DANIELS WELDING AND FABRICATION SERVICE

COUNTY OF JAMES CITY
FINAL SITE PLAN

RUNOFF ANALYSIS RESERVOIR PROTECTION ZONE
DANIELS WELDING & FABRICATION
SPECIAL USE PERMIT
HANKIN'S INDUSTRIAL PARK
JAMES CITY COUNTY, VA.
OCTOBER 31, 1989

RE: JO A4481, Daniels Welding and Fabrication Service, Case No. SP-123-89

INFILTRATION TRENCH

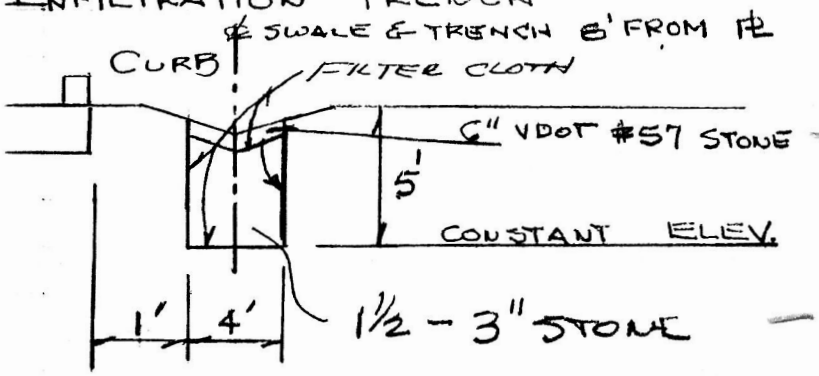
1½" - same stone as used below -

move location

1. Move trenches away from pavement @ least 10'
2. Change stone size on top to same as other stone
3. Soil test to verify infil rate is @ least
